RE: Indian Hills Unit No 30 abandonment SWD zone

APPLICATION FOR PERMIT TO DRILL, RE-ENTER, DEEPEN, PLUGBACK, OR ADD A ZONE

Indian Hills Unit #30
Before work to plug back
Devonian SWD

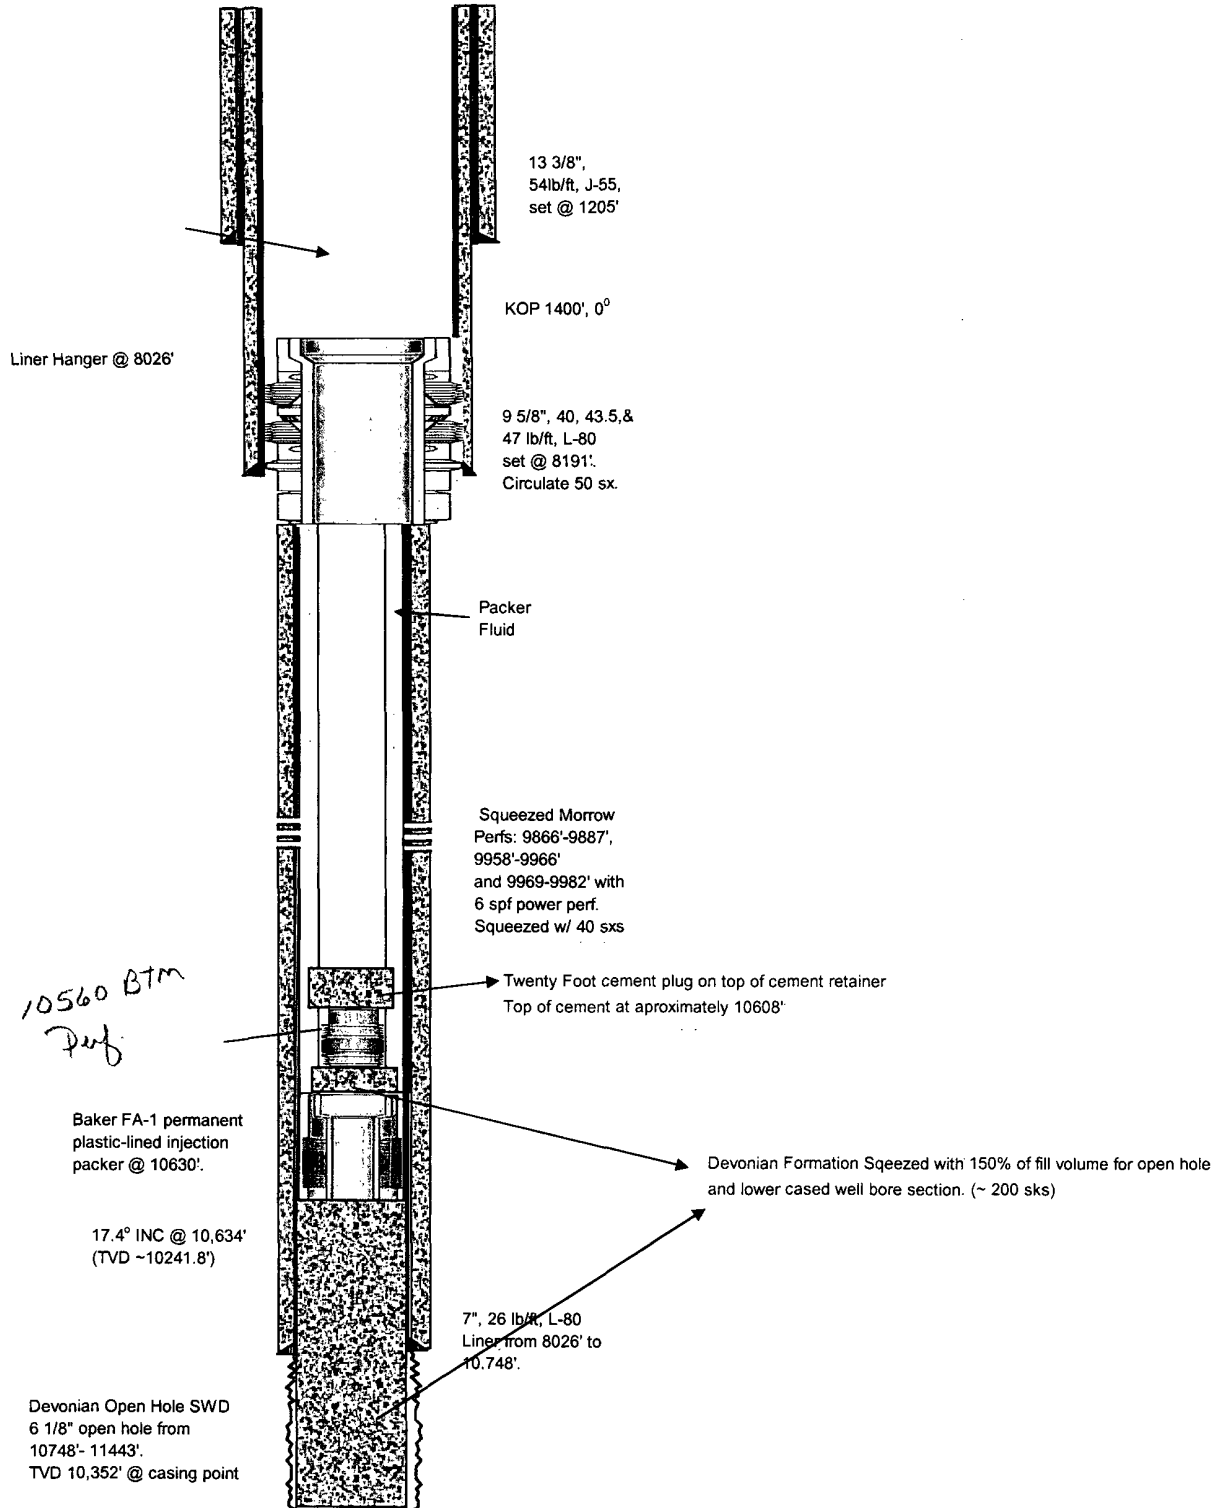
The C-101 accompanying this letter briefly outlines Marathon's proposal for abandoning the Devonian SWD zone in the Indian Hills Unit No 30. I contacted Mr. Mike Bratcher in your district office earlier this month about plugging this well. Mr. Bratcher advised that you wanted Marathon to remove the Baker permanent packer from the well and then set a cast iron bridge plug with 200 feet of cement on top of the CIBP. At the time of our discussion with Mr. Bratcher, Marathon was proposing to set a cast iron bridge plug above the packer and pump 50 feet of cement on top of the bridge plug.

Marathon has changed the proposal on our abandonment procedure in order to avoid the additional expense and possible problems of removing the Baker permanent packer, which would have to be drilled and fished or pushed to the bottom of the hole. We propose to set a cement retainer above the permanent packer and squeeze the entire open hole Devonian interval and the cased hole section of the well below the packer with 200 sacks of cement, which represents 50% excess over the calculated open hole volume. This is the approach used on Marathon's successful squeeze of the Devonian formation in the Indian Basin Gas Com No 1 (old acid gas disposal well). We would like to leave 20' of cement on top of the retainer in order to test the formations immediately above the permanent packer.

*As per call w/ Charles Kendrix & Ken Baker on 9-20-05 -
They will use A Packer not A Retainer - They will
Tag Cmt.*
